## JOINT REGIONAL PLANNING PANEL (Sydney West)

JRPP No	<b>2015SYW182</b>
DA Number	<b>608/2016/JP</b>
Local Government Area	<b>CITY OF PARRAMATTA COUNCIL</b>
Proposed Development	<b>DEMOLITION OF EXISTING STRUCTURES AND CONSTRUCTION OF A MIXED USE DEVELOPMENT CONTAINING 53 RESIDENTIAL FLAT UNITS AND 128 SQUARE METRES OF GROUND FLOOR RETAIL SPACE</b>
Street Address	<b>LOT 1 DP 135802, NO. 794 PENNANT HILLS ROAD, CARLINGFORD</b>
Applicant/Owner	<b>LATERAL ESTATE PTY LTD / COLES GROUP PROPERTY DEVELOPMENTS LTD.</b>
Number of Submissions	<b>SIX</b>
Regional Development Criteria (Schedule 4A of the Act)	CIV over \$20 million – General Development
List of All Relevant s79C(1)(a) Matters	<ul style="list-style-type: none"> <li>• List all of the relevant environmental planning instruments: s79C(1)(a)(i) <ul style="list-style-type: none"> <li>- State Environmental Planning Policy No. 65 – Design Quality of Residential Flat Development</li> <li>- State Environmental Planning Policy (State and Regional Development) 2011</li> <li>- The Hills Local Environment Plan 2012</li> </ul> </li> <li>• List any proposed instrument that is or has been the subject of public consultation under the Act and t

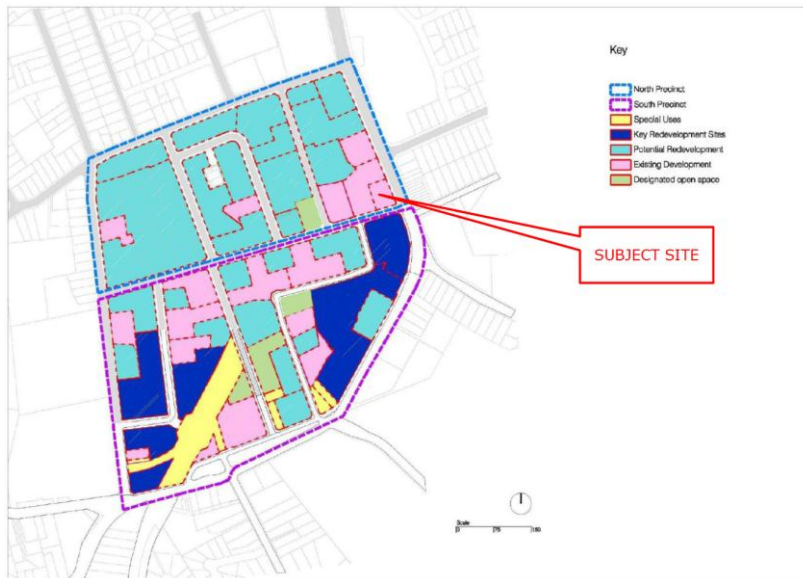
The Carlingford Precinct DCP contains a specific set of controls for the locality. The site is situated within the south east corner of the Northern Precinct of the Carlingford Precinct. It is not identified as a 'key site', however it is directly opposite one of the key sites known as "Block 16: Bunnings Site" at the corner of Pennant Hills Road and Post Office Street. It is noted that there is no expectation that the subject site and its immediate neighbouring properties have to be amalgamated in order to achieve larger development sites as illustrated in the Potential Site Amalgamation Guide Plan within the DCP (see diagram below).

The subject site is required to provide a minimum 10m setback to Pennant Hills Road and Post Office Street as shown in Figure 9 of the DCP (see diagram below).
